SI72.10-P-0002GH

Service Information: Modification of the front door

MODEL 163.113 /128 /136 /154 /157 /172 /174 /175

P72.10-2740-06

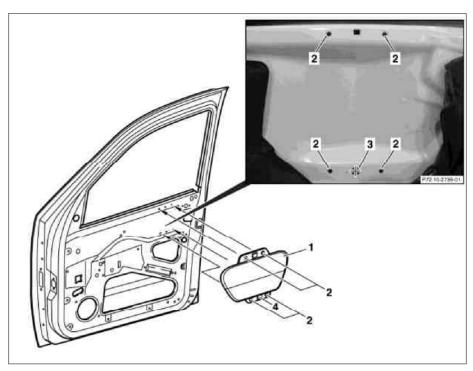
\fbox{i} Due to a design modification to the door skin, both parts must be checked when exchanging the door or the sidebag.

1	Check the replacement door to see if the aligning bore for the sidebag is present	i Should the replacement door not have an aligning bore and the sidebag is equipped with a fixing pin:	
		Modify the front door	SM72.10-P-0004A
2	Check to see of the fixing pin is present for the replacement sidebag	i If there is no fixing pin present on the sidebag, the door does not need to be modified.
